## SERVICE BULLETIN

No. SBM-202

### Modification MA2458 - Additional Securing of Nose Landing Gear Axle Bolt

## **MODIFICATION No. MA2458**

Castellated nut and split pin installation into SAB nose leg assembly  
(Sheet 1)  
FIGURE 1

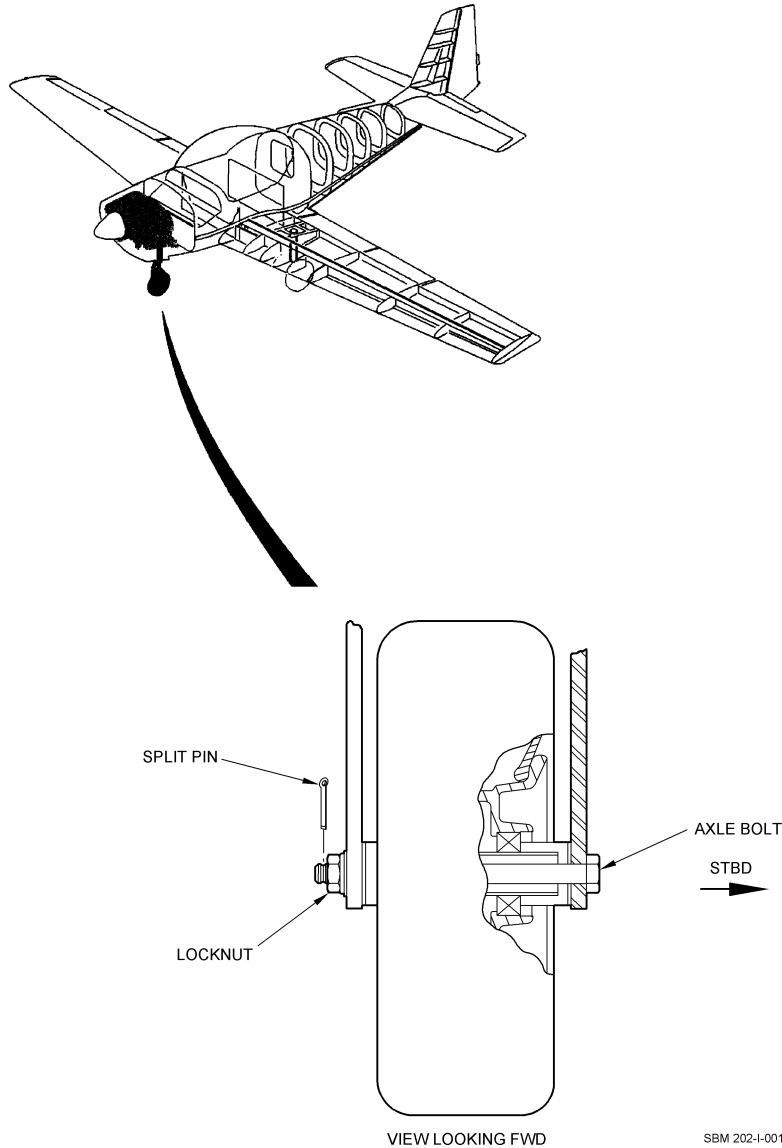
- (1) Modification MA2458 introduces additional securing of the nose landing gear axle bolt.

- (1) Remove the nosewheel locknut (Part No. HM14-100) from the axle bolt.
- (2) Referring to Fig 1, install a new nosewheel locknut (Part No. HM14-100) and tighten until the wheel drags, then back off one flat, ensuring there are enough threads showing for safety and to accomplish Step 4.

- (3) Check the installation of the nosewheel locknut (Part No. HM14-100) does not cause the SAB nose undercarriage forks to bend inwards, if it does then carry out Slingsby Aviation Service Bulletin 153 - SAB Undercarriage Nosewheel Fork Inspection.
  - (4) Drill a 3/32 in. hole, through the axle bolt not less than two threads from the axle bolt end.
  - (5) Ensure all swarf is removed and the work area is clean.
  - (6) Install the split pin (Part No. SP90-E11) through the axle bolt.
- D. REASSEMBLY
- (1) Remove the trestle support from under bump stop at aft of airframe.
  - (2) Lower the aircraft off the jack.
- E. RE-IDENTIFICATION OF THE UNIT
- (1) Not applicable.
- F. TEST
- (1) Not applicable.
